Access Compliance Report

Public Rights-of-Way

(Curb Ramps)

Intersection ID: N/A	Main Street: OLD_CONCORD_RD	Cross Street: ORCHID_BRIDGE_RD	Location: SW
ADA ID: AB27E1B1717D	Ramp Type: Perp	Initial Pass/Fail: Fail	Overall Compliance: No
		Severity Score: 10

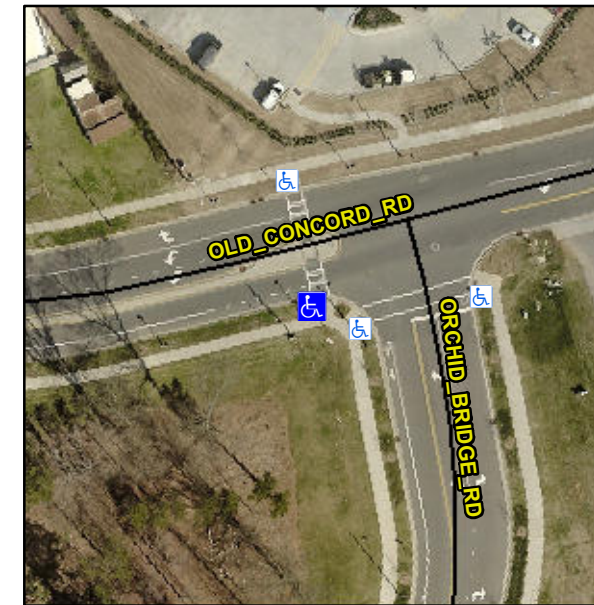
R304.5.1, R304.5.3

Compliance	Description	Data	Compliance	Description	Data
N/A	Ramp Length (in)	98.0	Yes	Ramp Slope (%)	8.2
No	Ramp Width (in)	46.0	No	Ramp XSlope (%)	3.3
N/A	Flare Type LT	N/A	N/A	Flare Type RT	N/A
N/A	Flare Slope LT (%)	N/A	N/A	Flare Slope RT (%)	N/A
N/A	Flare Traversable LT?	N/A	N/A	Flare Traversable RT?	N/A
N/A	Landing Length (in)	N/A	N/A	DWS Provided?	N/A
N/A	Landing Width (in)	N/A	N/A	DWS Contrast?	N/A
N/A	Landing Slope (%)	N/A	N/A	DWS Length (in)	N/A
N/A	Landing X Slope (%)	N/A	N/A	DWS Full Width?	N/A
N/A	Landing Curb? (Y/N)	N/A	N/A	DWS Offset (in)	N/A
N/A	Shared Landing?	N/A			
N/A	Gutter Ponding?	N/A	N/A	Gutter Slope (%)	N/A
N/A	Gutter Lip Ht (in)	N/A	N/A	Gutter X Slope (%)	N/A
N/A	Painted X Walk1?	Yes	N/A	Painted X Walk2?	N/A
	X Walk 1 Direction	To N		X Walk 2 Direction	N/A
N/A	X Walk 1 Width (in)	94.0	N/A	X Walk 2 Width (in)	N/A
	X Walk 1 Slope (%)	4.4		X Walk 2 Slope (%)	N/A
	X Walk 1 X Slope (%)	0.7		X Walk 2 X Slope (%)	N/A

Remove & Replace Entire Ramp.
